# AGENDA

## March 16, 2017 Standards Committee Meeting

RE: Agenda for the March 16, 2017 Standards Committee Meeting

**404-2.03(02) Permanent Metal Forms [Rev. May 2013, Rev. Mar. 2017]**

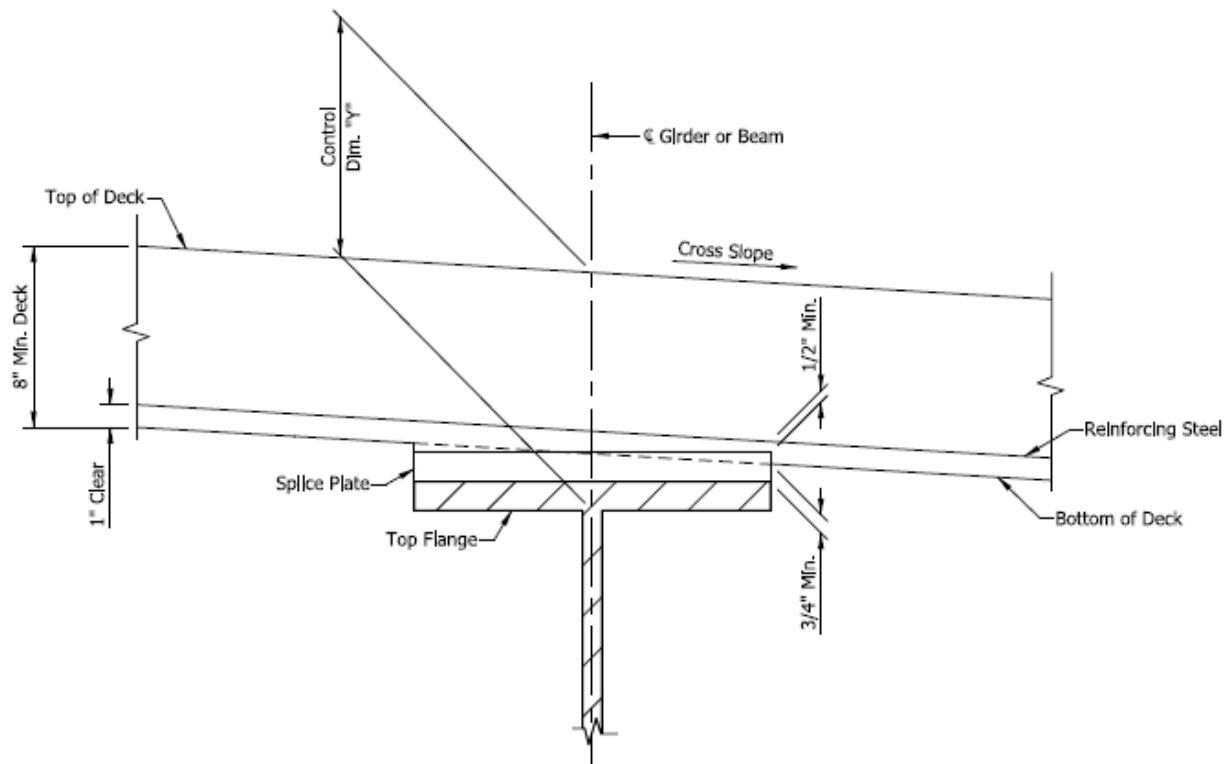
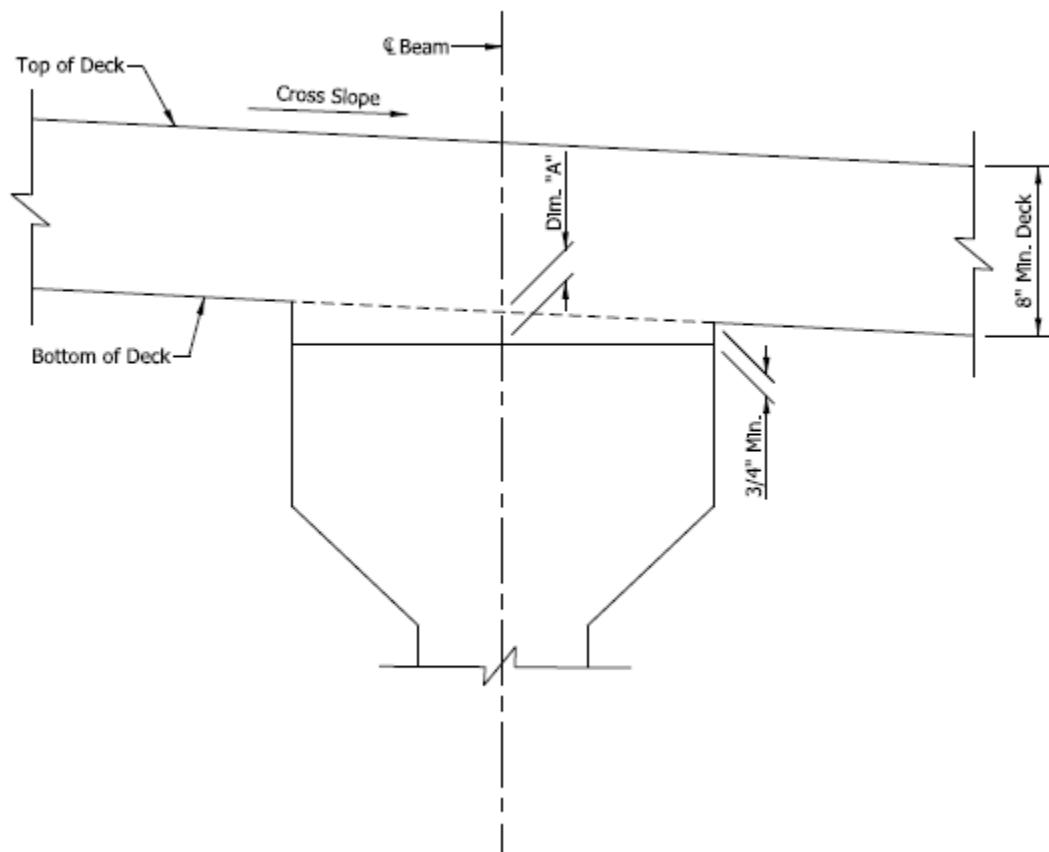
The enforcement of the projection limits has undesirably led to the angle being field cut, thus modifying the properties of the angle. While the modifications can be overcome with closer weld spacing, field personnel must record and relay the amount cut from each support between several beams and overall several spans. For precast beams, the angle is cast into the beam at the spacing required for the expected load.

PROPOSED SOLUTION: Create an RSP to limit the angle leg projection relative to the SIP form pan. Revise deflection requirements to align with AASHTO guidance.

Design of permanent metal forms is the responsibility of the contractor in accordance with INDOT *Standard Specifications* section 702. Designers should account for the use of forms as described in Chapter 403-2.03.
